The Commission has issued the enclosed Amendment No. 21 to Facility Operating License No. DPR-65 for the Millstone Nuclear Power Station, Unit No. 2. The amendment consists of changes to the Technical Specifications in response to your application dated July 21, 1976.

MILLSTONE NUCLEAR POWER STATION, UNIT NO. 2

Amendment No. 21  
License No. DPR-65

SAFETY EVALUATION BY THE OFFICE OF NUCLEAR REACTOR REGULATION  
SUPPORTING AMENDMENT NO. 21 TO FACILITY OPERATING LICENSE NO. DPR-65  
NORTHEAST NUCLEAR ENERGY COMPANY  
MILLSTONE NUCLEAR POWER STATION, UNIT NO. 2  
DOCKET NO. 50-336

FIGURE 3.2-2

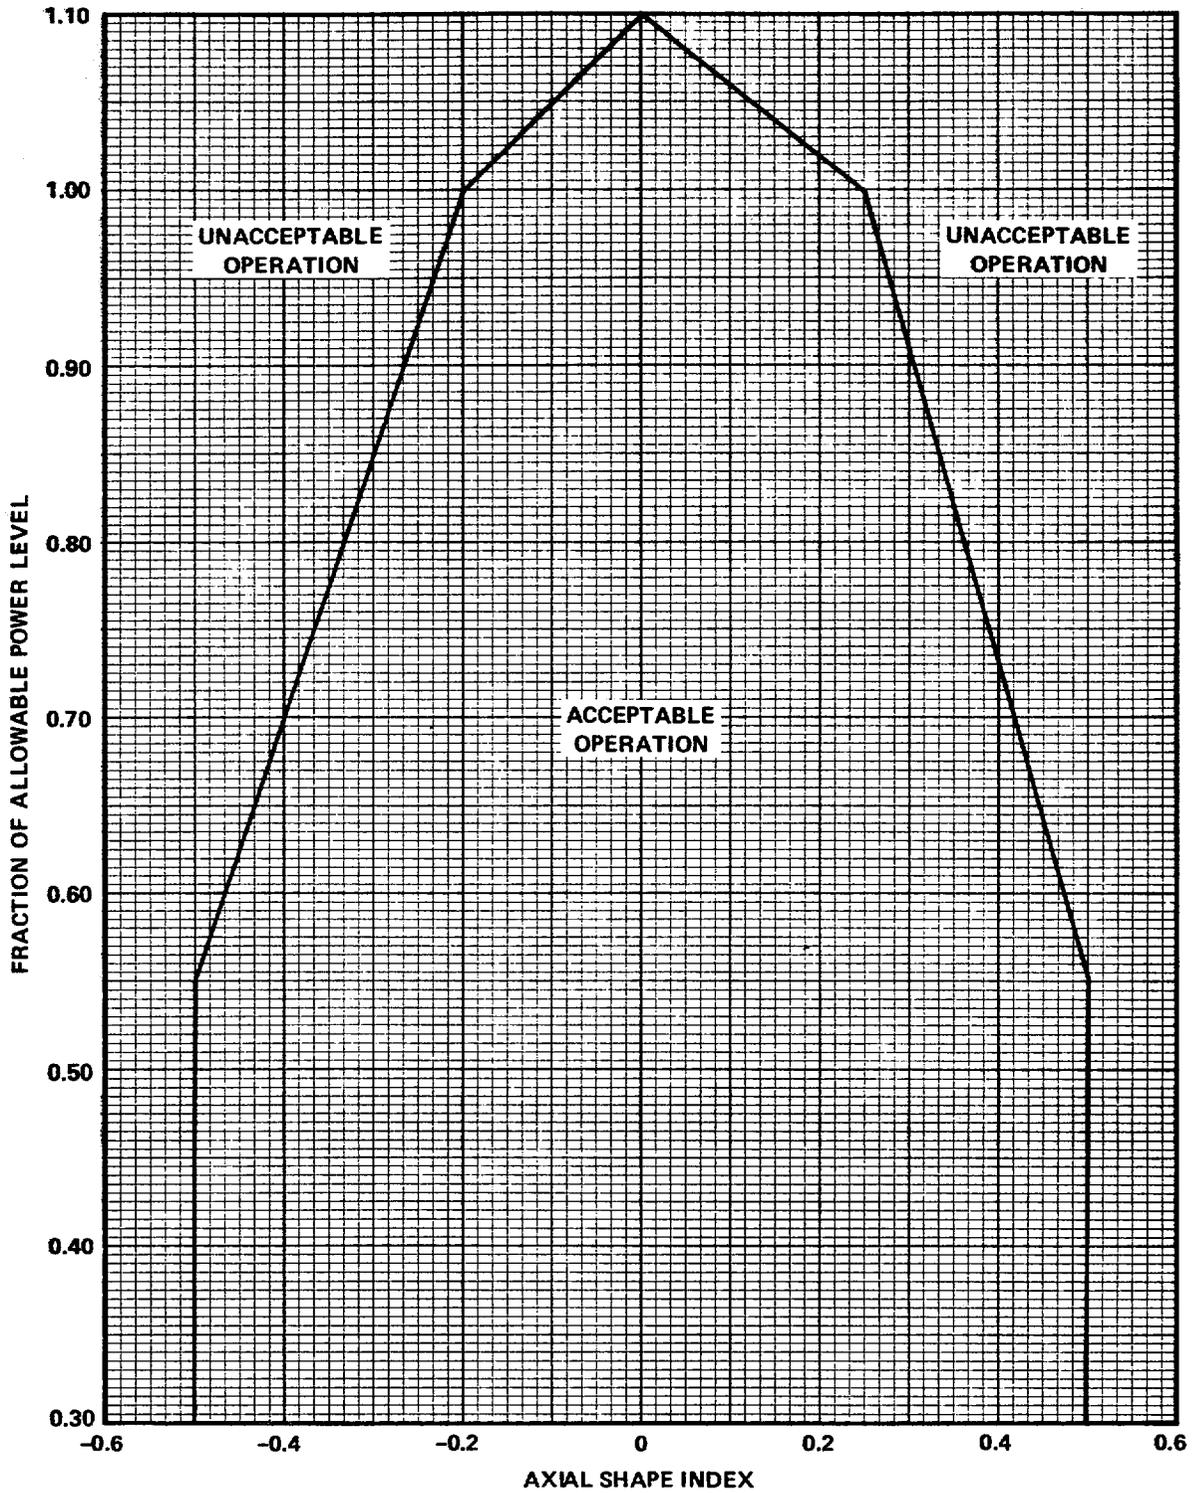
Technical Specification 4.2.1.2 contains Figure 3.2-2 which shows the limiting values of the Axial Shape Index (ASI) as a function of the fraction of allowable power level. This curve is the plot of ASI values for which the Linear Heat Generation Rate (LHGR) equals the Loss of Coolant Accident (LOCA) limiting LHGR ( $LHGR_{max}$ ). The ASI curve is characteristically shaped like a "teepee" in which the limits of the ASI become smaller with increasing power. The point of the "teepee" is scaled to approximately 99% of full reactor thermal power: The ordinate of the ASI curve is given in relative units from 0 to 1.1 with a scaling factor defined as  $(L) M/17.0$  where L is the maximum allowable LHGR and M is the reactor thermal power limit. Since the Technical Specifications limits  $LHGR_{max}$  to 15.3 KW/ft, the ordinate of the point of the "teepee" is scaled to 1.1 (15.3/17.0) which is equivalent to 99% power.

At the present time, Technical Specification 4.2.1.2 limits power to 89% reactor thermal power, when operating the reactor using excore detectors. This restriction was imposed in order to prevent operation near the point of the "teepee" where a small variation in ASI would lead to operation outside of the ASI "teepee" limits. NNECO's application for license amendment dated July 21, 1976 requests deletion of this reactor thermal power level restriction.

As indicated above, the ASI curve contained in Figure 3.2-2 contains limiting values of ASI for which the peak LHGR equals  $LHGR_{max}$ . Thus, provided that the reactor is operated below 99% of the maximum allowable reactor thermal power level, operation within the constraints of the ASI curve will assure that  $LHGR_{max}$  is not violated. For this reason operation of the reactor utilizing excore detectors, above the current (Technical Specification) power restriction of 89% power but below (the ASI "teepee" limited) 99% power does not involve a decrease in the safety margin associated with the LOCA limiting LHGR (i.e.,  $LHGR_{max}$ ). Since the safety margin associated with the LHGR has not been decreased, the consequences of a LOCA will not be more severe in terms of peak clad temperature and oxidation than those previously analyzed for operation between 89% and 99% power.

In terms of actual operation of the reactor utilizing excore detectors operation at higher power levels is more likely to result in violation of the limits of the ASI curve. This possibility exists, as noted above, because the ASI teepee (band width) becomes more narrow with increased power. As a consequence and because of limited experience utilizing excore detectors, the present power level restriction was imposed in the Technical Specifications. Since that time, sufficient experience utilizing excore detectors has been obtained assuring that operation within the more narrow ASI limits can be achieved.

At the present time, if the ASI limits are exceeded, Technical Specification 3.2.1 requires that reactor operation be restored within the limits of the ASI curve in one hour or that the reactor be brought to the hot standby condition within four hours. In order to counter the increased probability that the ASI limits will be exceeded at power levels above the present restriction of 89% reactor thermal power, the licensee proposes that Technical Specification 3.2.1 be revised to require that (1) at power levels above 89% reactor thermal power if the measured value of ASI exceeds allowable limits, reactor operation must be restored within the limits of the ASI curve within fifteen minutes or reduce the reactor power to be equal to or below 89% power and (2) if the ASI limits are exceeded at power levels equal to or below 89% power, reactor operation must be restored within the limits of the ASI curve within one hour from initially exceeding the limits of the ASI curve or bring the reactor to the hot standby condition within four hours. For example, if reactor operation occurred outside of the ASI limits for 15 minutes above 89% power, operation within the ASI limits below 89% power must be achieved within 45 minutes or the reactor must be in the hot standby condition within the next 4 hours. The hot standby condition is defined as average reactor coolant temperature and neutron multiplication factor ( $K_{eff}$ ) are  $>300^{\circ}\text{F}$  and  $<0.99$ , respectively.

Although it is more likely that operation above 89% reactor thermal power will lead to violation of the ASI limits, the allowable time to achieve operation within the ASI limits above 89% power has been sufficiently shortened so as not to significantly increase the cumulative time that the reactor is operated outside of the ASI limits. Thus, the joint probability of a LOCA coincident with reactor operation outside of the ASI limits is not significantly different from that previously considered.
